NUMBER: 21-019-06

Idle RPM Flare During Cold Vehicle Operation - Revised Transmission Oil Fill Level

2006	(LE)	300C/Touring (International Markets)
2005 - 2006	(WH)	Grand Cherokee (International Markets)
2006	(XH)	Commander (International Markets)

Fig. 1 LE OIL LEVEL/TEMP CHART

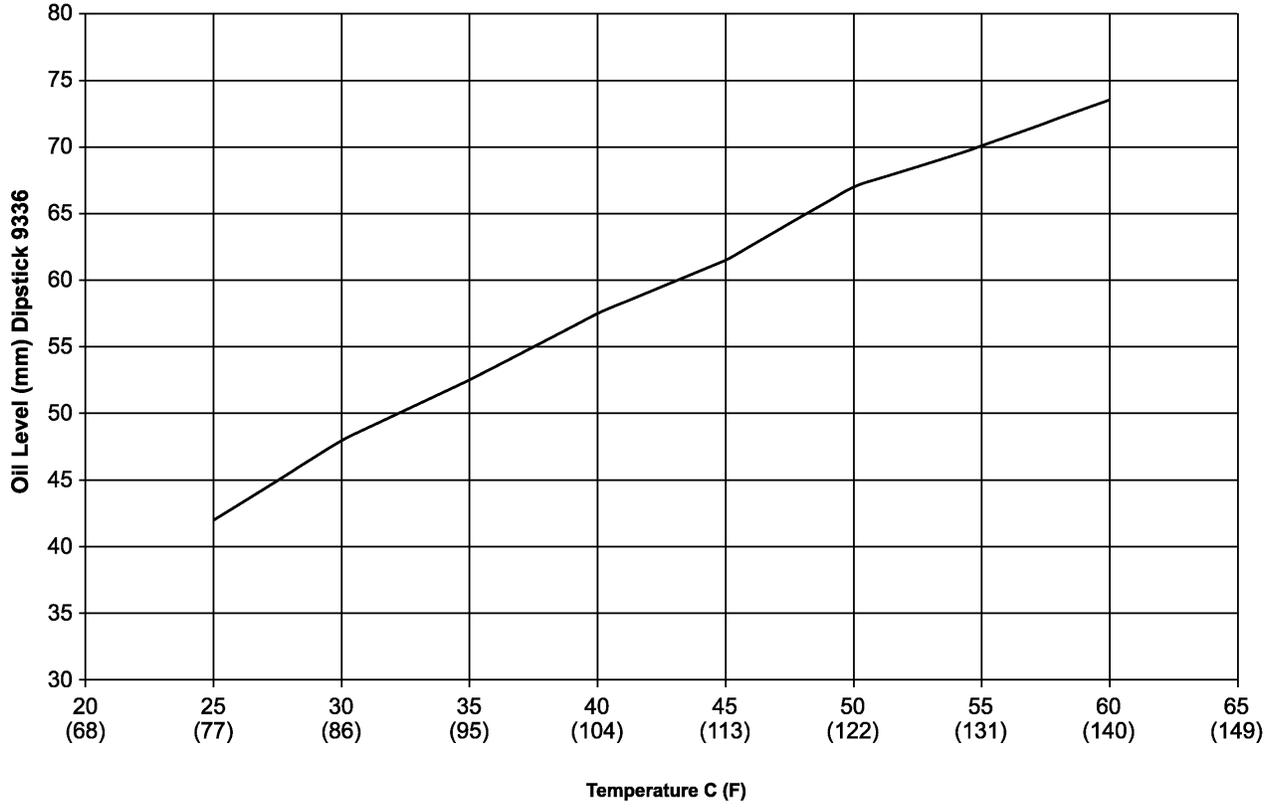
8. The transmission Oil Dipstick 9336 has indicator marks every 10 mm. Determine the height of the oil level on the dipstick and use the following oil height/temp charts for LE (Fig. 1) or WH/XH (Fig. 2)

NOTE: The charts reflect revised oil levels.

1. Add or remove oil as necessary to bring the fluid to the correct level.
2. Install the dipstick tube cap with new locking pin pn 05093746AA.
